CORRIGENDUM

Organigramme 2C - Origine du feu

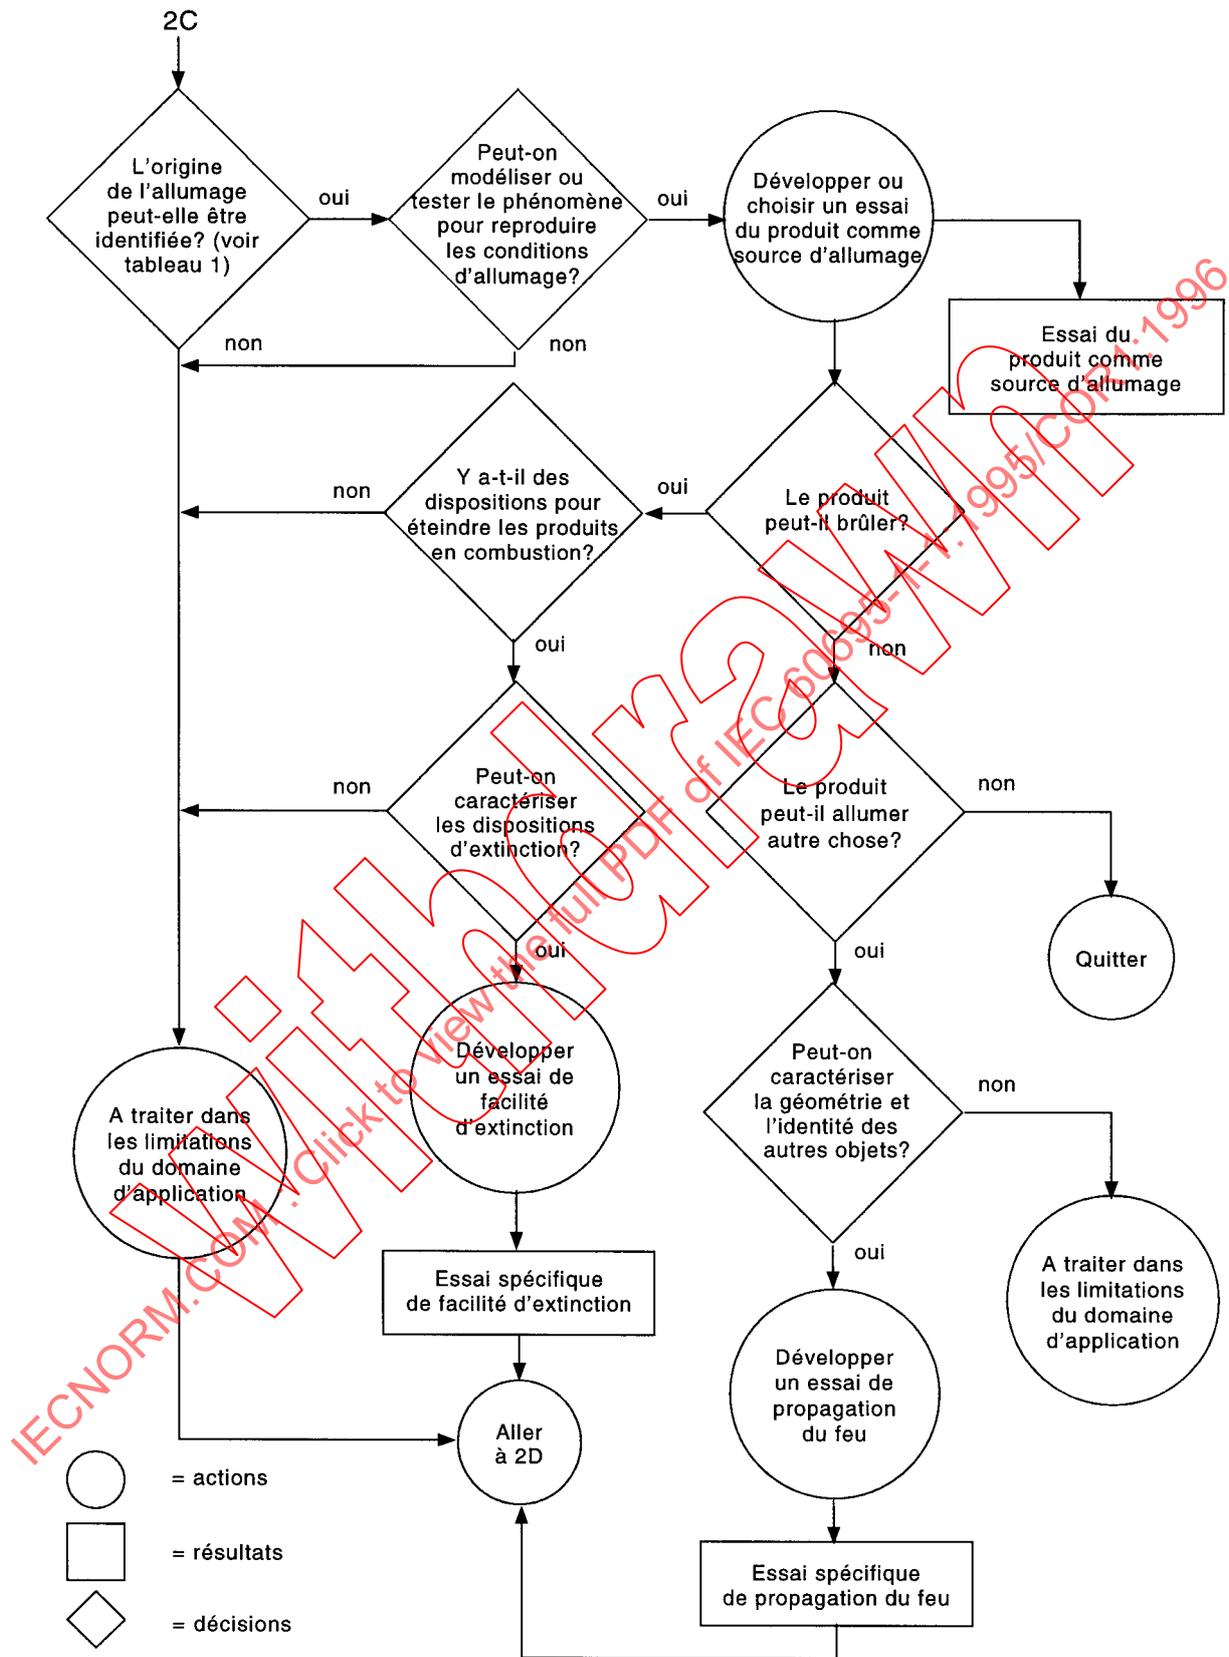
Organigramme 2C

La flèche à gauche du carré de décision Le produit peut-il brûler? doit être inversée, c'est-à-dire que la flèche doit pointer vers le carré de décision: Y a-t-il des dispositions pour éteindre les produits en combustion?

Flow chart 2C - Origin of fire

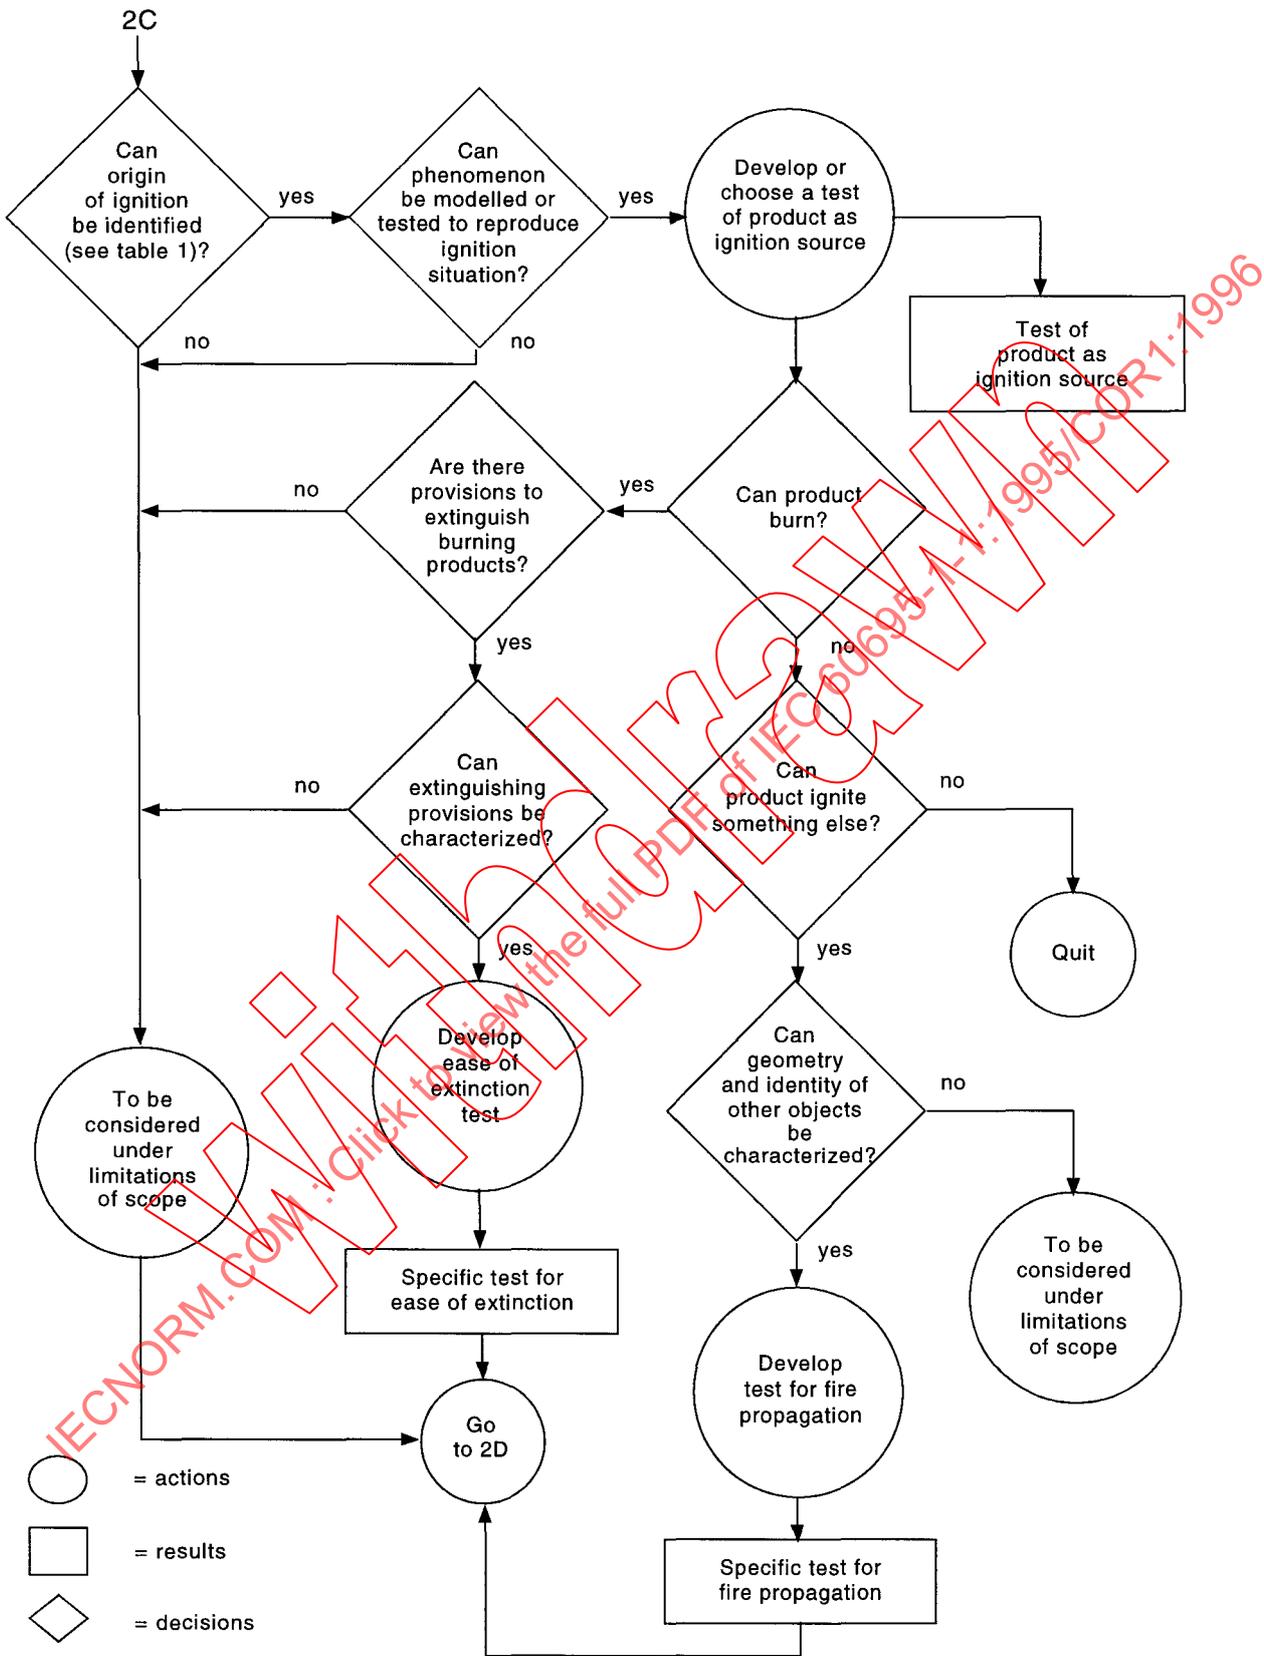
Flow chart 2C

The arrow to the left of the Can product burn? decision box should be reversed; i.e., the arrow should point towards the Are there provisions to extinguish burning products? decision box.

Organigramme 2E - Autres objets non électrotechniques combustibles (facultatif)

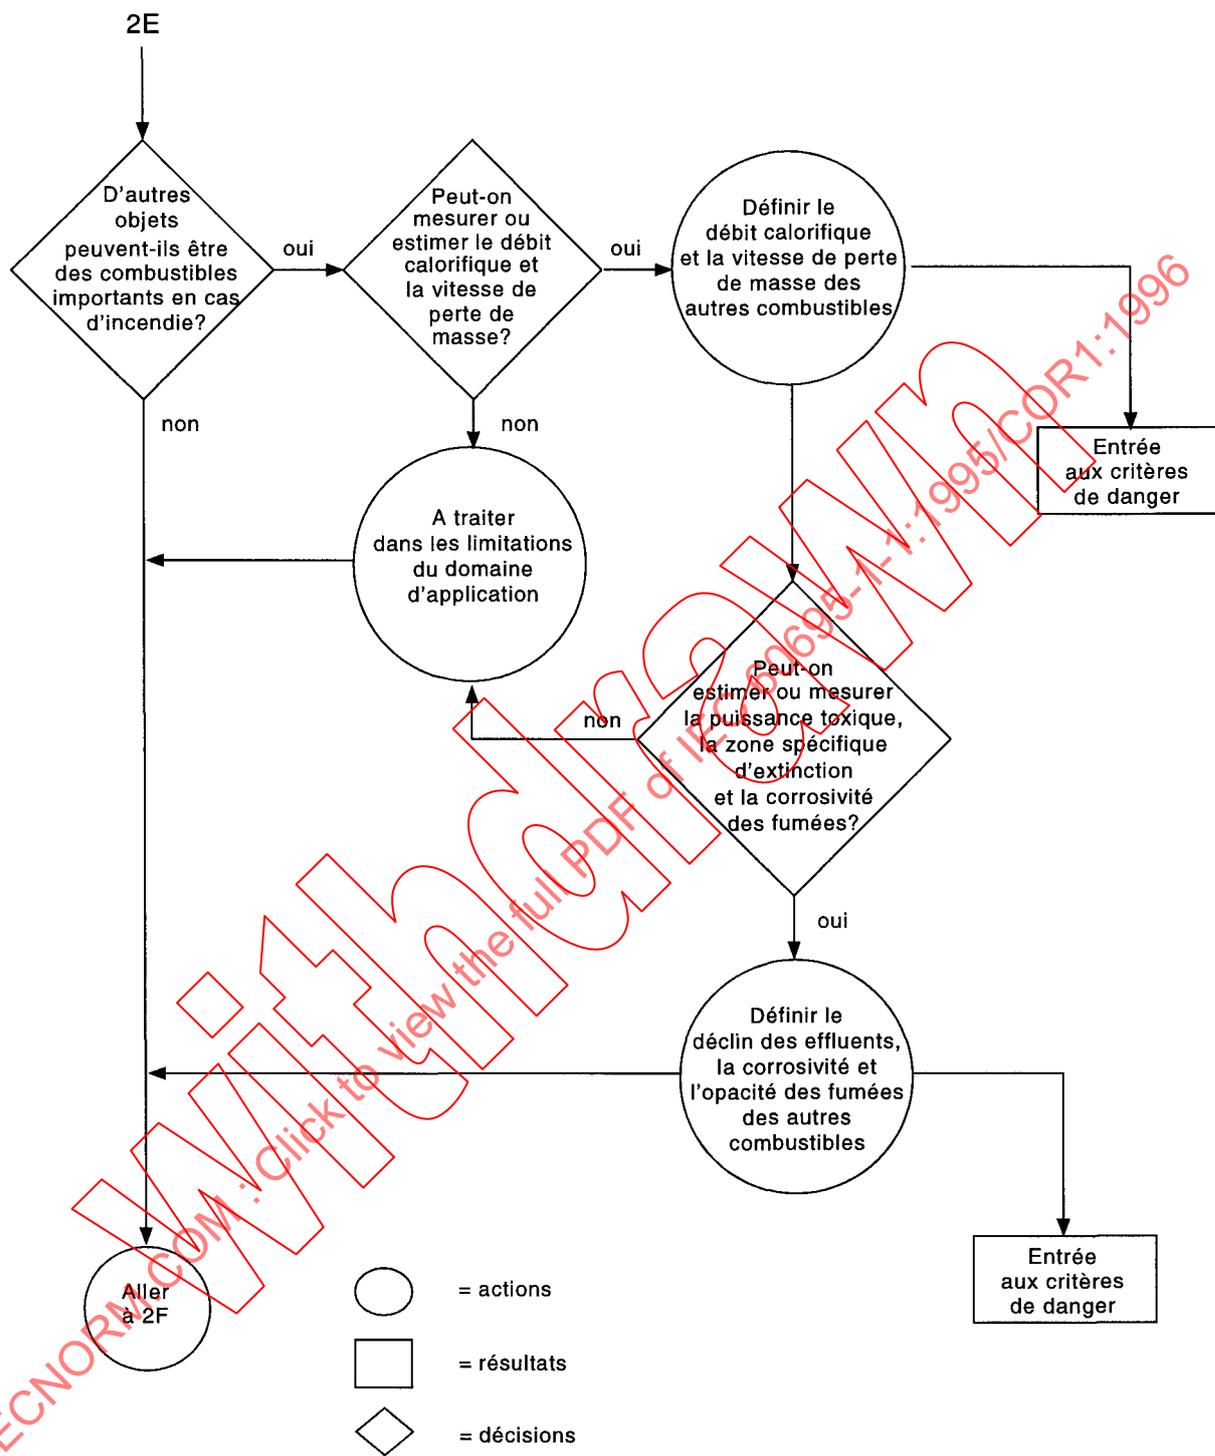
Organigramme 2E

a) *La ligne sous le cercle d'action Définir le débit calorifique et la vitesse de perte de masse des autres combustibles doit être une flèche pointée vers le bas, vers le carré de décision qui indique: Peut on estimer ou mesurer la puissance toxique, la zone spécifique d'extinction et la corrosivité des fumées?*

b) *Dans le cercle d'action de l'angle inférieur gauche, au lieu de Aller à 2E lire Aller à 2F*
